December 15, 2020

**Re: Coastal Development Permit (CDP) Application Number 2-20-0319  
(Mirada Road Soil Nail Wall and Pedestrian Bridge Replacement Project)**

Exhibit 1 – Alternative 2 Alignment

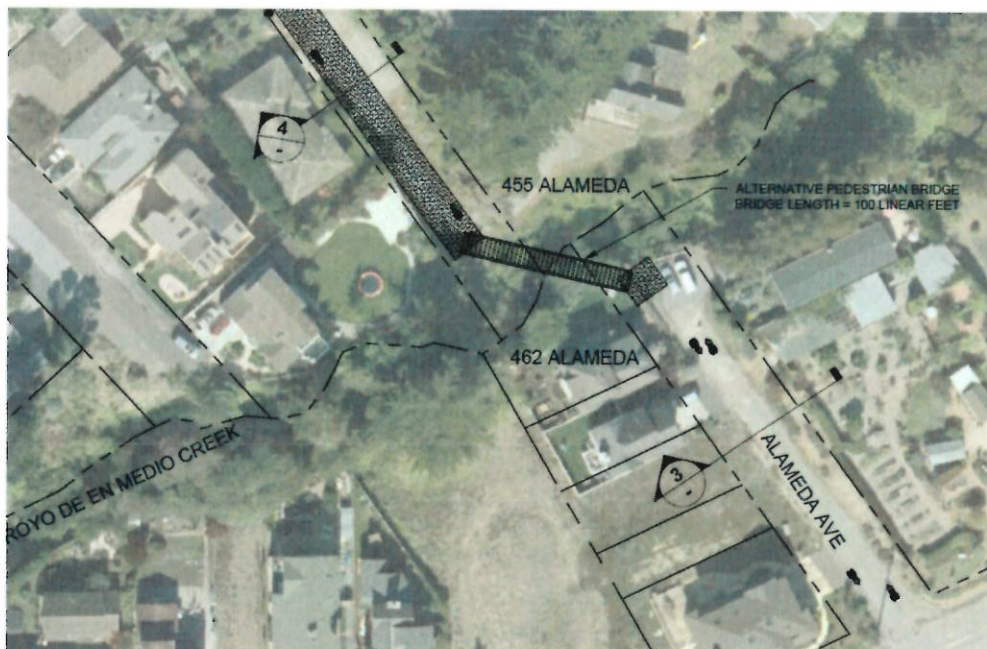
For Alternative 2, please estimate potential impacts to riparian vegetation or the creek bed from installing the bridge and foundation in this location. In addition,

please discuss the feasibility of installing a longer free span bridge that will not require construction of foundational elements within the creek or adjacent riparian area.

As shown in Exhibit 1 below, the proposed bridge would be about 95 feet long and would be a free span bridge across the Arroyo de en Medio. While the bridge's abutments would be clear of creek vegetation, the bridge's construction would require trimming and removal of riparian vegetation and mature trees as shown in Exhibits 2 and 3. For a bridge that is 12 feet wide, the total area of impact would be about 1,140 square feet. Note that this alternative varies from the previous configuration as we believe the approaches with curves is likely cost prohibitive to construct.

Note that installation of the bridge at this location will likely require right of way acquisition from 462 and 455 Alameda Avenue. As previously noted, the relocation of the bridge to Alameda Avenue will require trail improvements to the north and south that will be disruptive to numerous private properties. Acquisition of new public right of way or easements would be necessary and could take many years while the existing bridge will further deteriorate.
